APPROVED 19 JULY 1956 REVISED (A) 23 MARCH 1966 (B) 30 MARCH 1973 © 28 MARCH 1977

P.A. WC Other Cust SH 99	TITLE COCK, DRAIN, SPRING KEY, 50 P.S.I.	MILITARY STANDARD MS35784
PROCUREMENT SPECIFICATION MIL-C-1203	SUPERSEDES: AN770 and CDAX1 in part	SHEET 1 OF 1

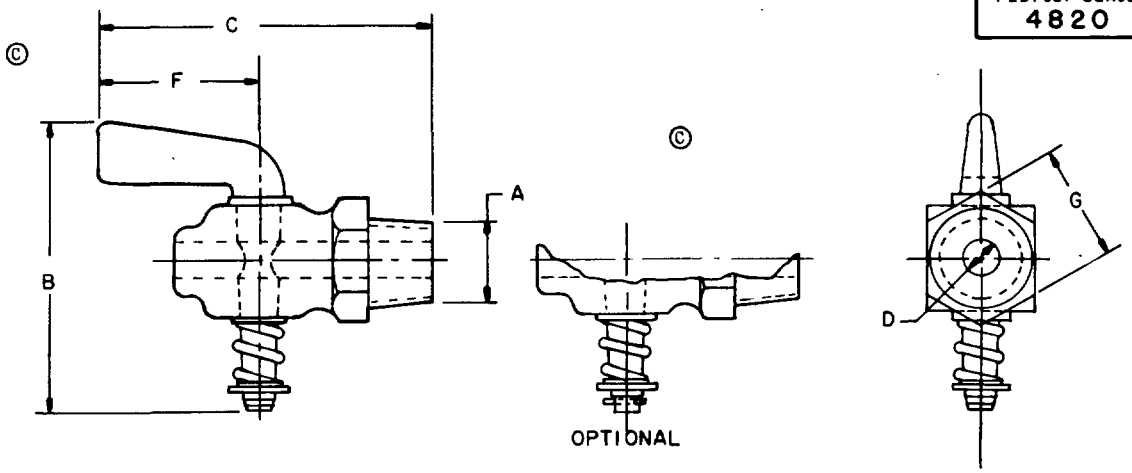
©* INACTIVE AFTER 28 MARCH 1977. NO SUPERSEDING STANDARD.

©1. MATERIAL: Body, Handle, Stem and Screw - Brass, manufacturer's standard
Washer, Spring Retainer and Pin - Manufacturer's standard
Spring - Phosphor Bronze, QQ-W-321, Alloy Number 510, or
Carbon Steel, QQ-W-428, or
Corrosion Resisting Steel, QQ-W-423, Composition 302, 304, 305, 316, 321, 347: Condition B.

©**9. CAUTION: If other than phosphor bronze spring is used be aware of possible spark and explosion.

© Denotes changes.
